EARLY DESIGN GUIDANCE 2

2203 23rd Ave S.
Seattle, WA, 98144

3034772-EG

Design Review 11.24.2020

EDG 2 REVISED PREFERRED OPTION 3

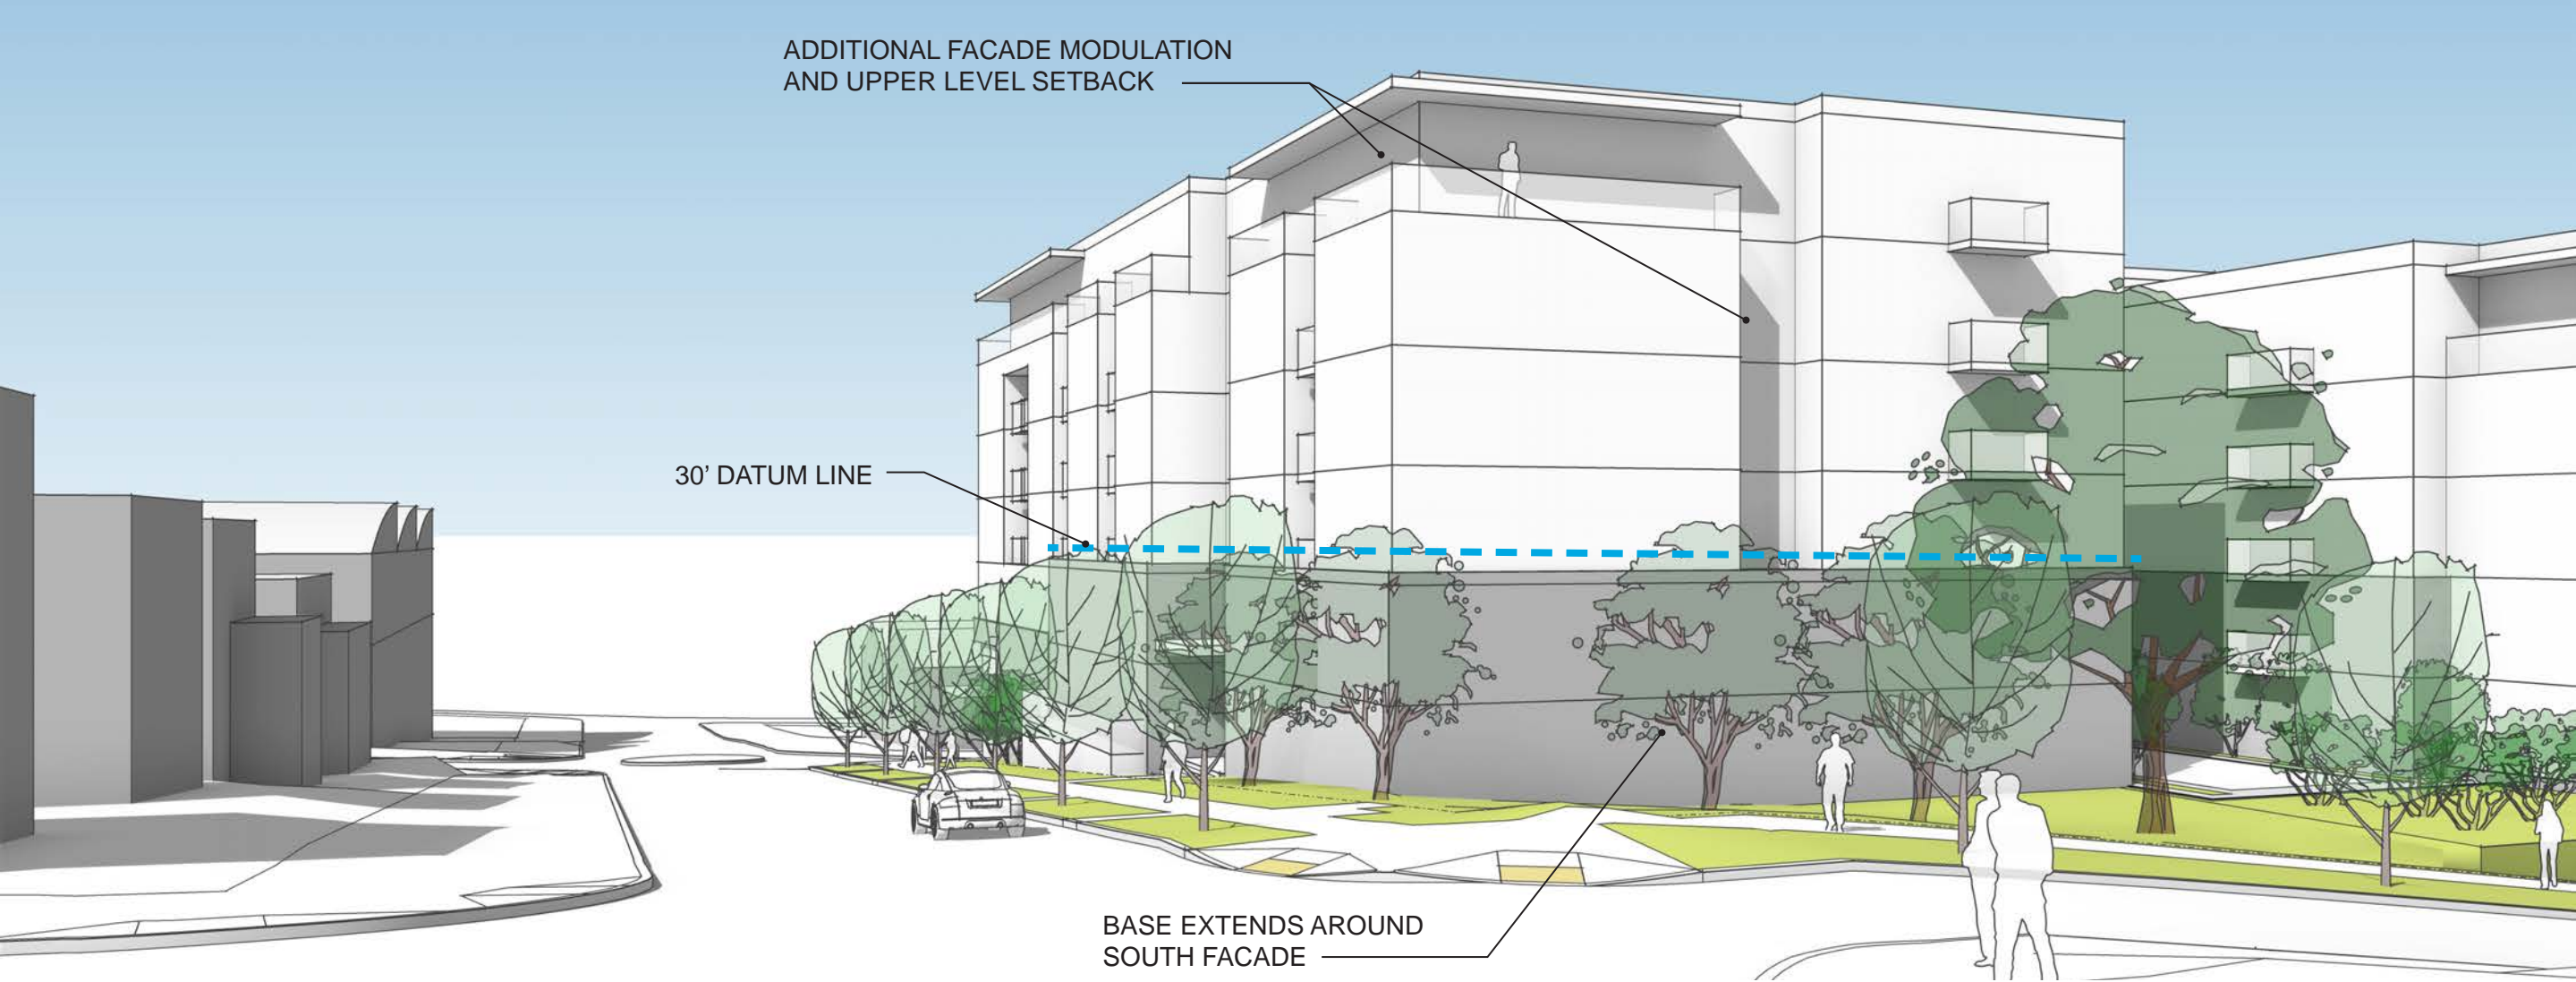
Staff is concerned with lack of modulation and scale of the uninterrupted building facades on the west and south sides of the project site. The west and south building facades face the adjacent residential small lot (RSL) zoning district, which has a maximum building height of 30 feet. Echoing public comment, staff recommends breaking up the perceived mass and scale of the building using a combination of building setbacks, façade articulation, and secondary material treatment. Incorporate an initial break in the buildings mass on the west and south sides at the maximum height limit of the properties across 22nd Avenue South and South College Street. Additional steps or recessed massing should be incorporated into the upper levels along the west and south facades to further minimize the perceived bulk to the structure. (DC2.A.2, CS2.D.3)

EDG 2 REVISED PREFERRED OPTION 3

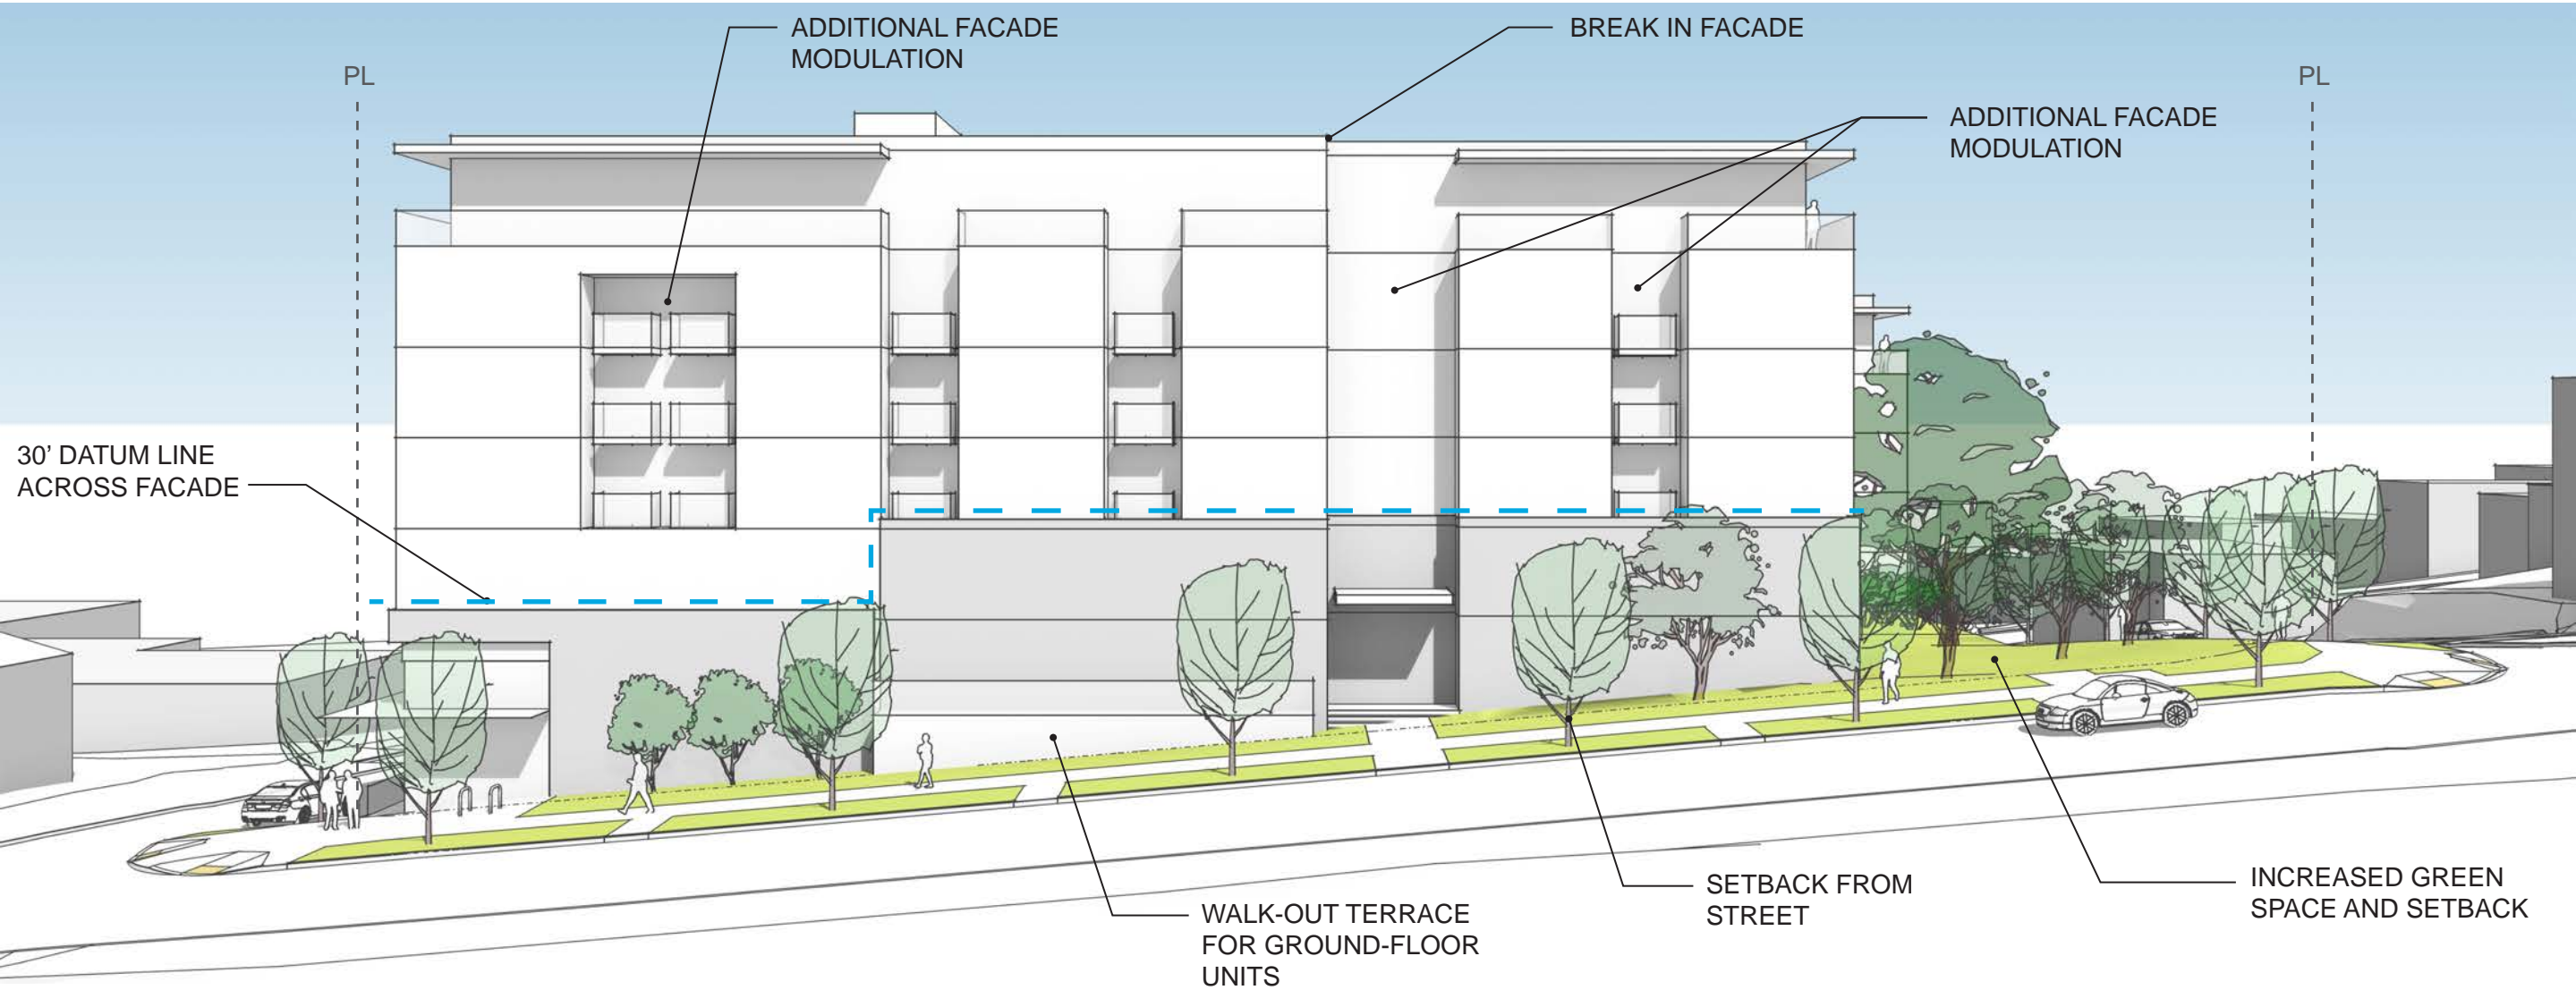
COMMENT 1.B (CONTINUED)

The south and west facade were studied in greater detail and further modulated along both facades to help add depth and interest to the facade while helping to break down the scale of the building. The proposed design utilizes these steps to address the concerns regarding the scale of the building and how it fits into two different contexts surrounding the block:

- 1. The previously proposed cantilever on the southwest corner was removed and a 30' datum was introduced along the facade to help balance the building and provide a weighty, more residential feel to the corner. (CS2-C3, DC2- C3)

EDG 2 REVISED PREFERRED OPTION 3

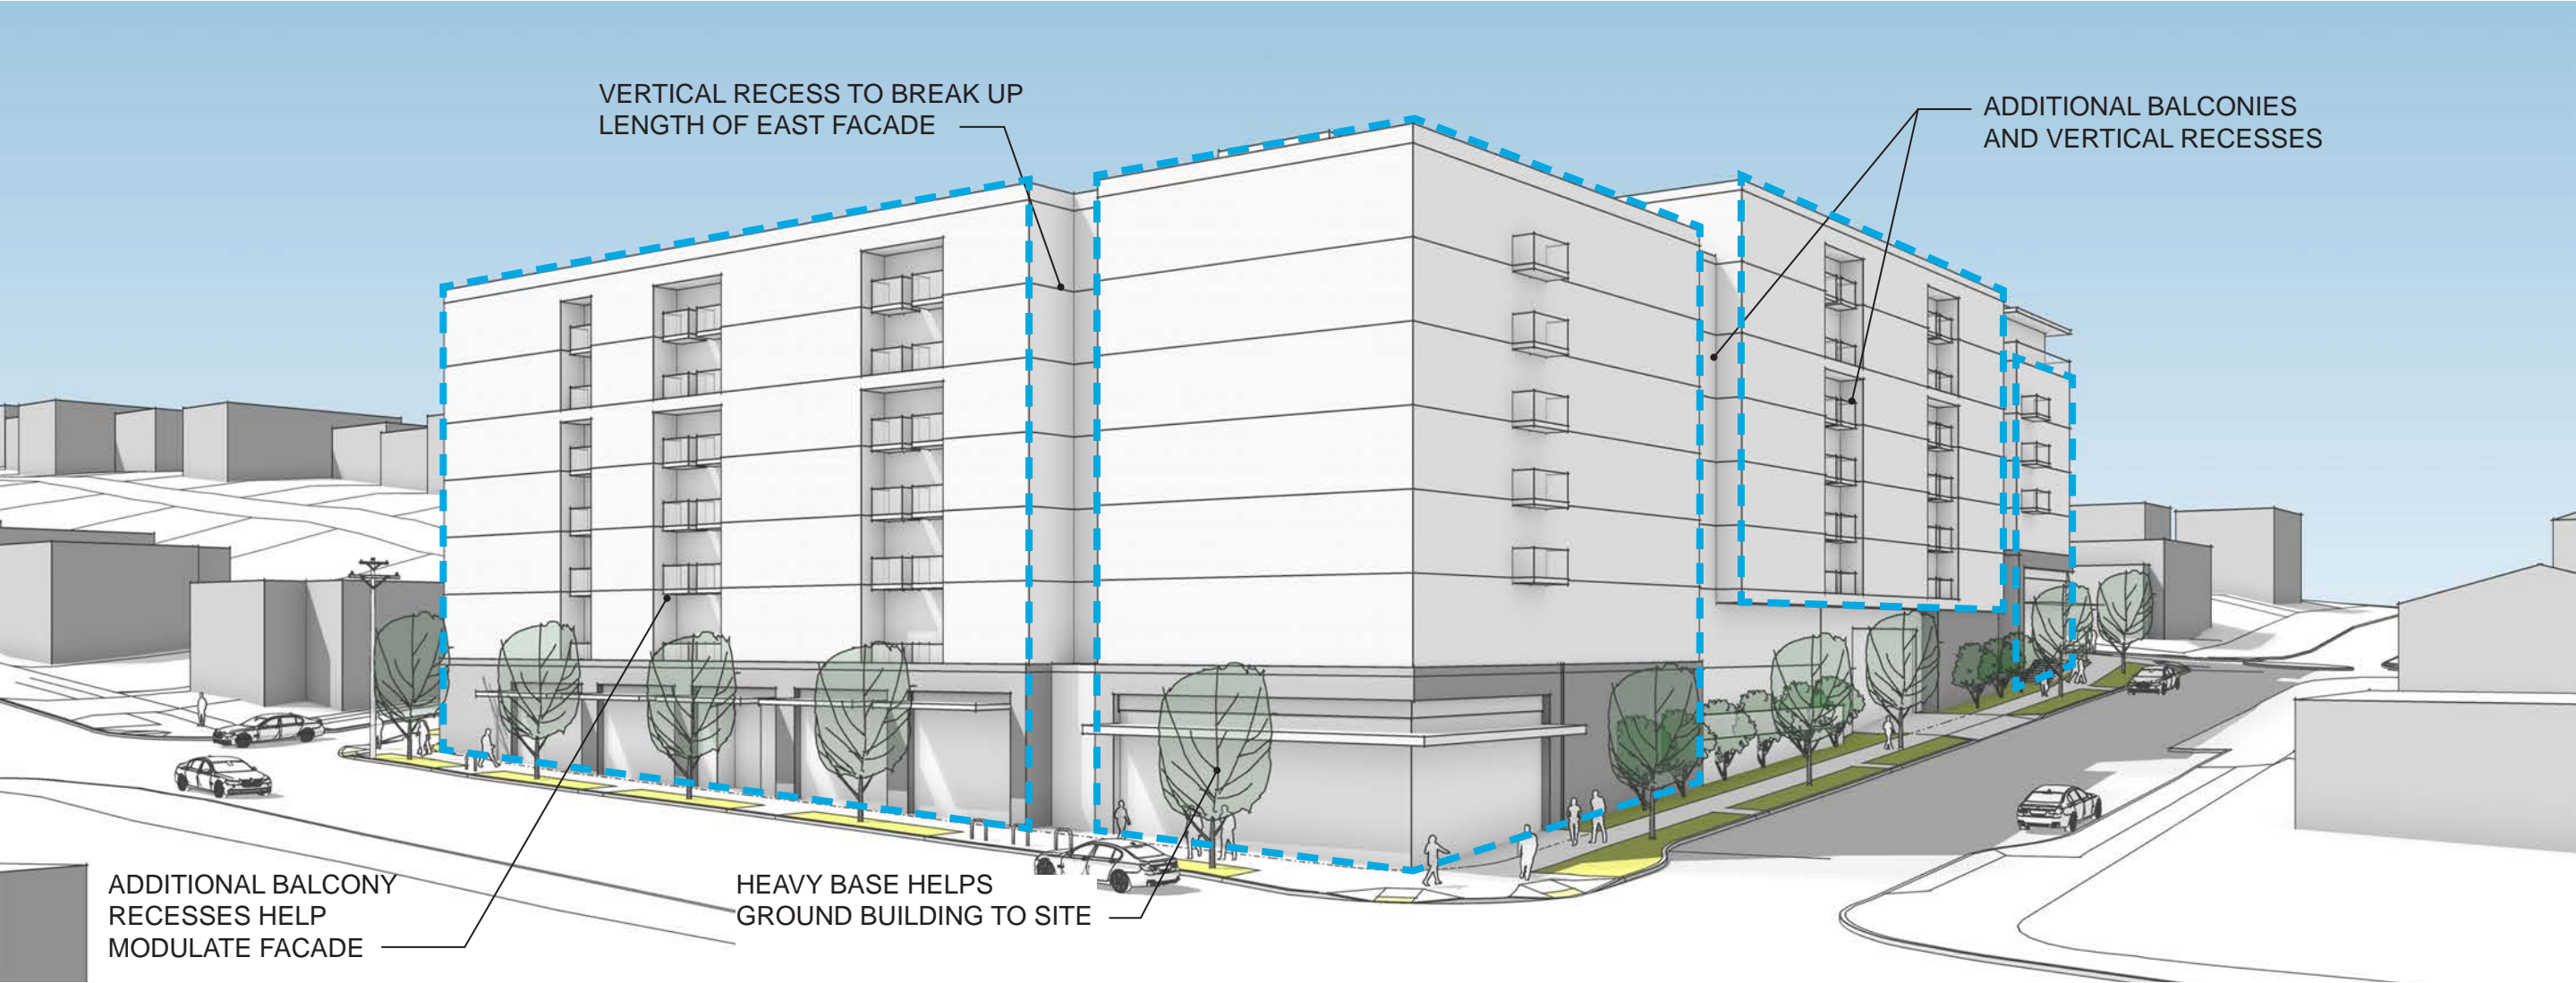
On the north and east facades, introduce façade articulation and the inclusion of secondary architectural elements to provide visual depth and interest to the building. Although the adjacent zoning to the north and east permits a similar size and scale building to staff’s recommended option (Option 3 alternative), the existing development pattern of one and two story commercial buildings warrants further treatment on these two facades for visual interest. (DC2.A.2, DC2.C.1)

- 1. Similar to the south and west facades, additional recesses in the north and east facades were introduced to help break up the bulk of the building into several, smaller masses. (CS2-C3)
- 2. Balcony insets further break up mass and provide additional modulation and rhythm on the facades. (CS2-C3, DC2-A2, DC2-C1)
- 3. Horizontal break line is introduced on the taller mass along 23rd Ave S, S Walker St, as well as on the SE corner. This break visually divides the 6-story façade into a 4-story and 2-story portions. This design solution helps reduce the perceived height. (CS2-D3)
- 4. A brick base is proposed along the east facade to reflect the character of adjacent commercial buildings and to introduce a human-scaled touch to the facade. (CS2-C3, DC2- C3)

NORTH FACADE

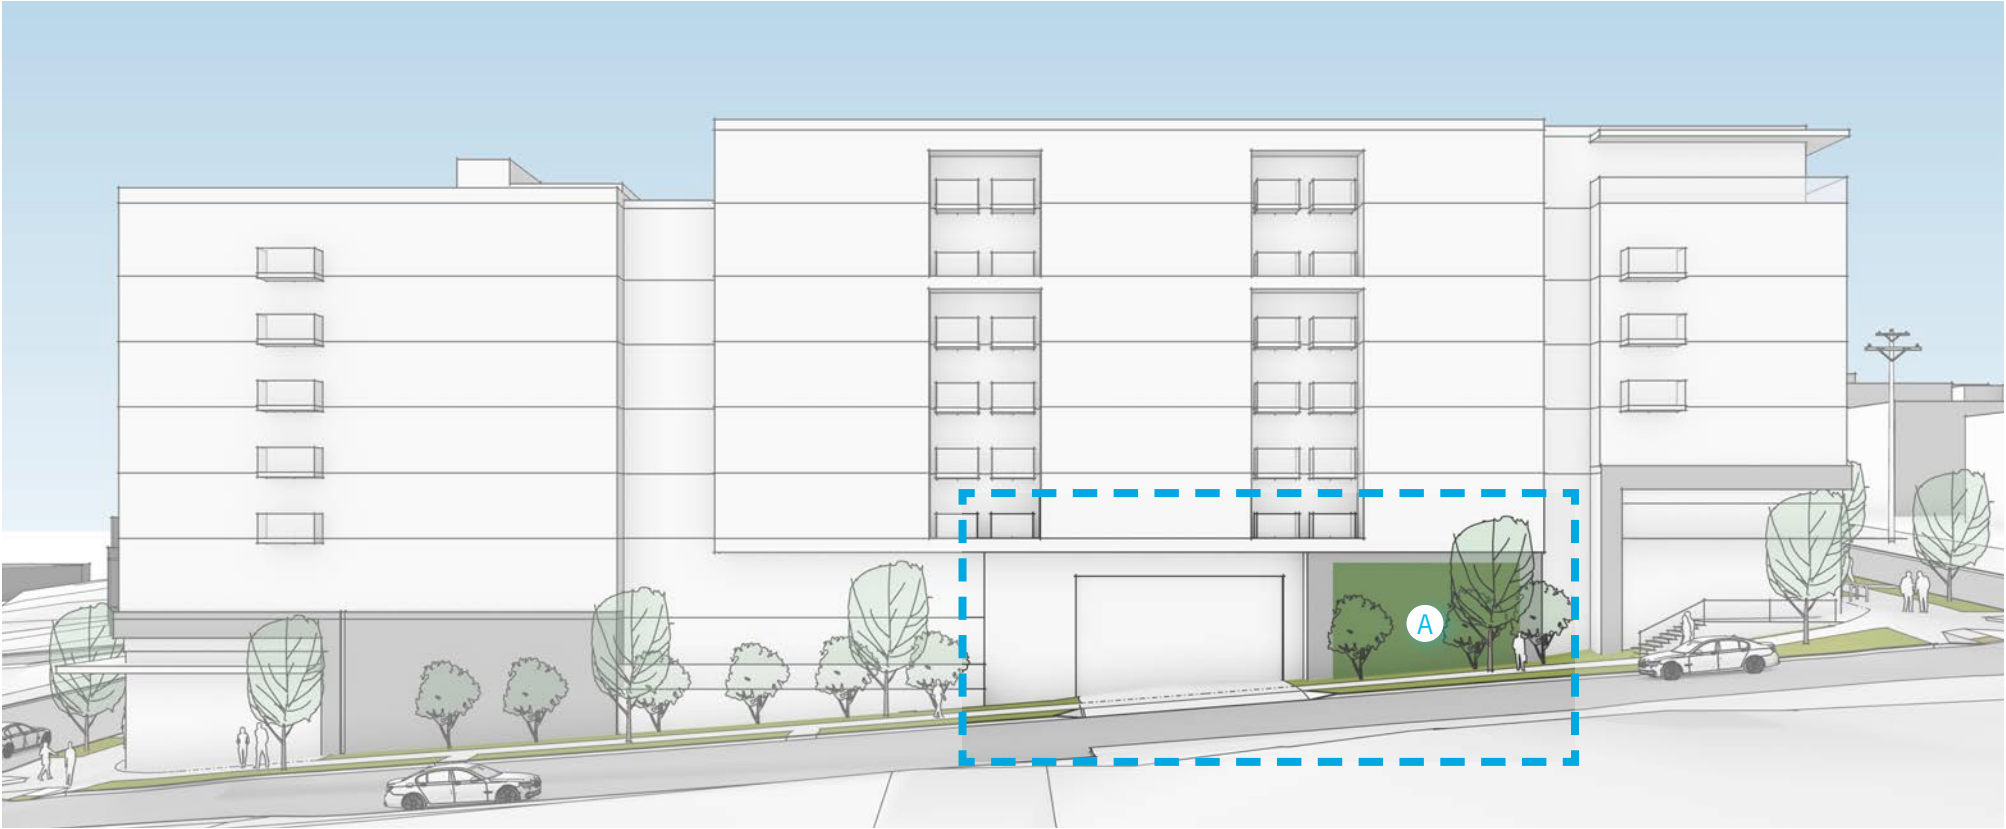
Staff agrees with public comment and supports locating access to the on-site parking and trash storage area off South Walker Street, but is concerned with the potential blank wall condition created by grouping both the garage access and utility/trash storage room. Staff recommends the applicant explore materials and secondary architectural features to create an aesthetically pleasing garage entrance and trash room that fits into the overall context of the building design. In the next design please provide example materials and street level illustrations demonstrating your intended design direction to address this issue. (DC1.C.2, DC2.B.2)

A green wall is proposed on the street-level façade adjacent to the garage entry door. The green wall will be of a cable system installed in a visually pleasing pattern, a type of ‘mural’ that serves as a reminder of what used to exist on the project site. In addition to providing a visual interest along the sidewalk, the green wall will also offer added greenery to the area. (DC1-C2, DC2-B2)
